TEMPORARY REVISION

AMM-TR-MÄM-42-1235

Placard Overview Correction

This Temporary Revision AMM-TR-MÄM-42-1235 is approved in conjunction with the Mandatory Design Change Advisory MÄM 42-1235 and is valid in conjunction with the Airplane Maintenance Manual (AMM) until this Temporary Revision has been incorporated into the AMM.

Figure 1: Exterior Placards

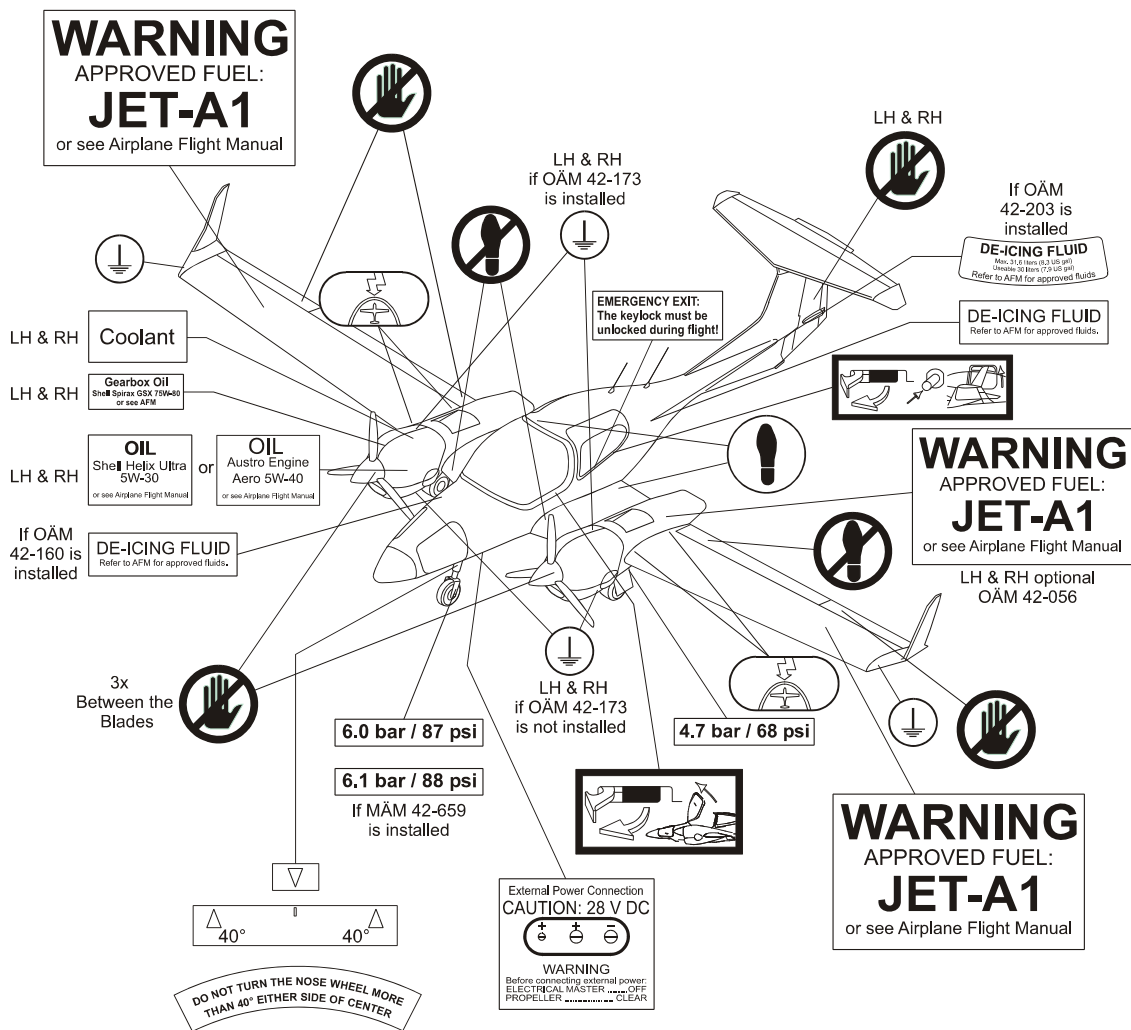
Figure 1 is amended to read:
